SCOTTS VALLEY GROUNDWATER MANAGEMENT PLAN (AB 3030)

**ADDENDUM TO
SCOTTS VALLEY
GROUNDWATER MANAGEMENT PLAN
(AB 3030)**

COMMENTS AND RESPONSES

October 1994

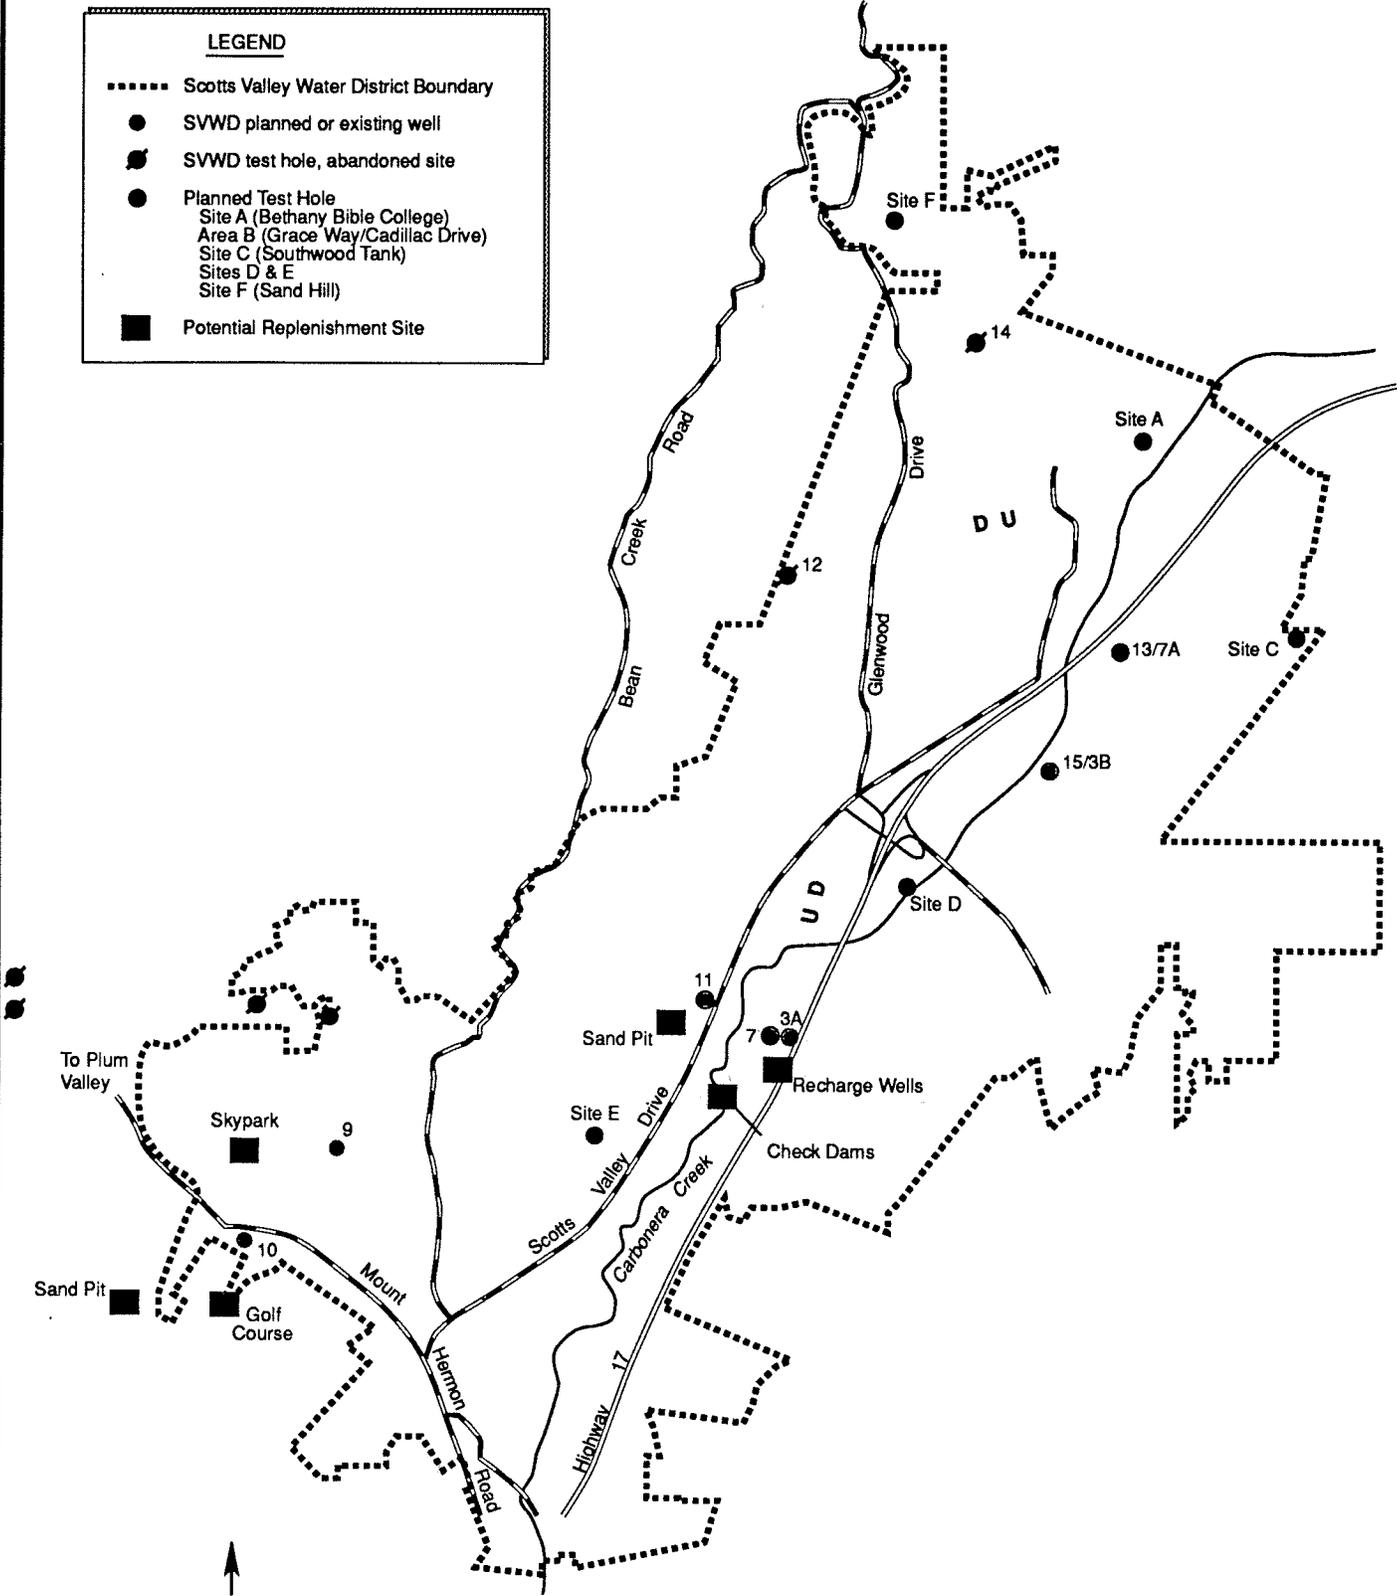
12. Page 43... It may be useful to have a map made locating potential project areas, the El Pueblo treatment plant, Skypark, Bean and Carbonera Creeks, and major wells for either injection or recovery. It would also be helpful if it was at the same scale as the groundwater elevation contour map.

A: Comment noted. Such a map was prepared for the September 8, 1994 presentation, with acknowledgement that it should have been prepared for and included in the report. This map is attached.
